COUNCIL REPORT

**SUBJECT: METRO VANCOUVER 2ND NARROWS WATER SUPPLY TUNNEL
VALVE CHAMBER LOCATION**

PURPOSE: To provide a recommendation to Council on the preferred location and configuration for the 2nd Narrows water tunnel valve chamber.

Figure 1 – Original Design

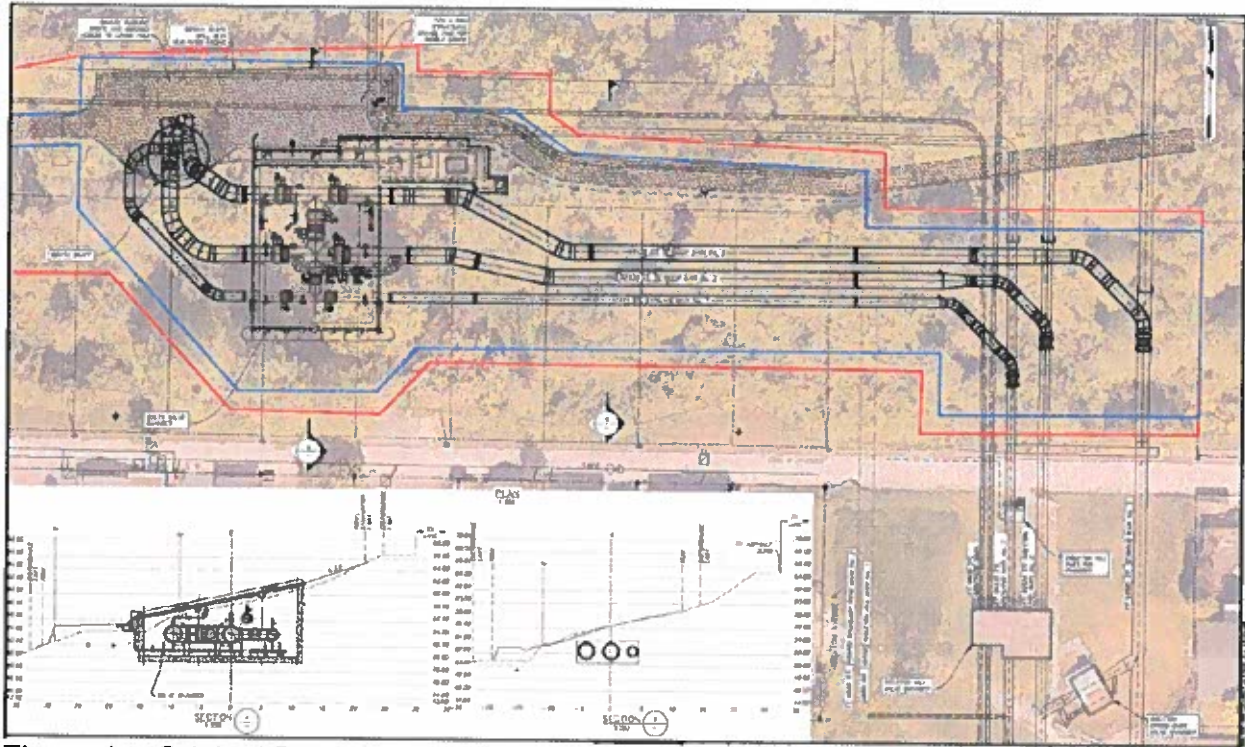
Option 1 is the original design proposed by Metro Vancouver (see Figure 1). The valve station is sited directly adjacent to the tunnel shaft.

Although Option 1 has a larger impacted area than Option 3, the area impacted is mostly populated by invasive species. So despite the larger permanent SRW, Metro Vancouver would remove the invasive vegetation and restore the area with native vegetation which would be a benefit to the park.

Figure 2 – Valve Station in Ingleton Road Allowance

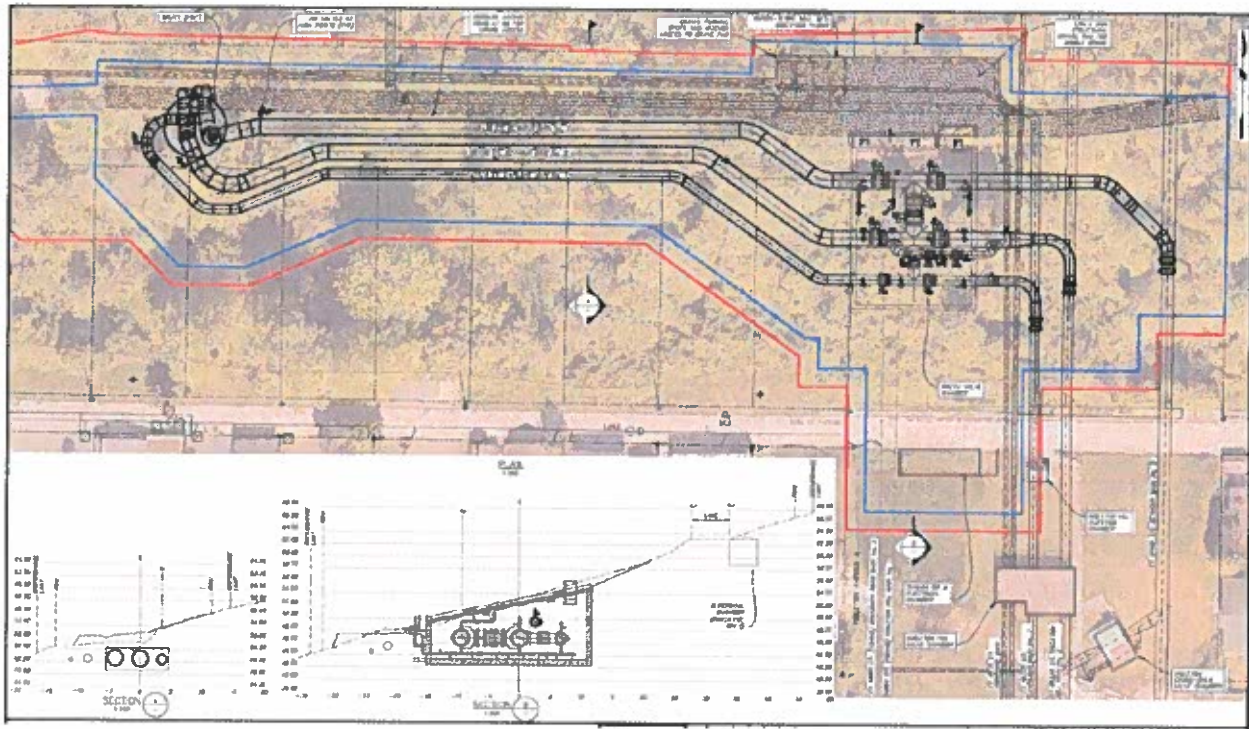
Option 2 has the valve station sited about 100m east of the original design in the Ingleton road allowance see (see Figure 2).

Option 2 has the highest cost, impacted area, and tree removal. It also has the highest construction risk of the three options because the valve station and connecting water mains are in close proximity to the existing water mains. The three major components of the works (the shaft, valve chamber and electrical room) are distributed over a larger area in Option 2 whereas these major components are consolidated in one area in the other two options.

Figure 3 – Modified Original Design

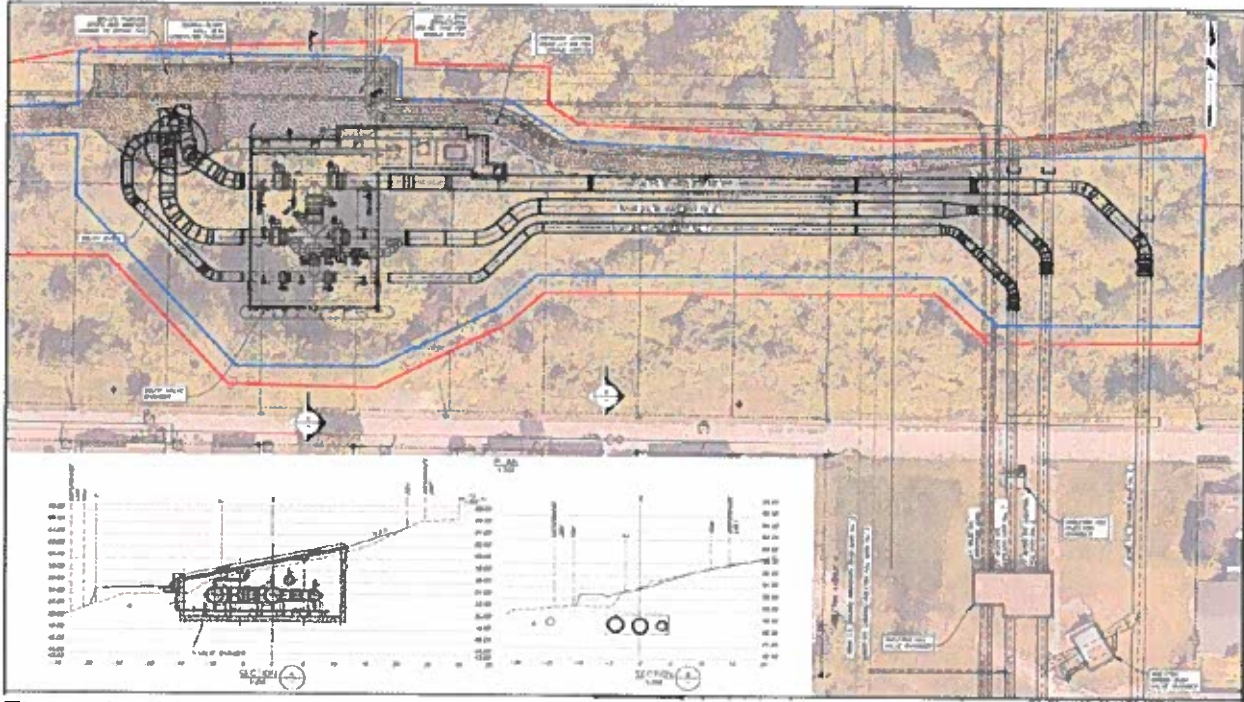
In Option 3, the valve station is sited in the same place as the Option 1 original design. The difference in Option 3 is the connecting water mains have been shifted slightly north to reduce the area required for SRW and construction (see Figure 3).

Option 3 has the least tree removal, the smallest area of disturbance, and the smallest permanent SRW. However, Option 3 carries a higher construction risk than Option 1 because the connecting water mains in Option 3 are closer to existing water mains that must remain in-service until the new water supply tunnel is put in service. As a result, Option 3 will cost more than Option 1 to address the extra excavation, shoring, and geotechnical investigation that is required to protect the existing water mains.

Weighing all the considerations, Staff believes Option 3 strikes the best balance between minimizing permanent impact on the park and mitigating cost and risk to the project. Staff recommends that Council approve the preparation of the statutory right of way and construction access agreement consistent with Option 3 for the valve station location and configuration as outlined in this report.
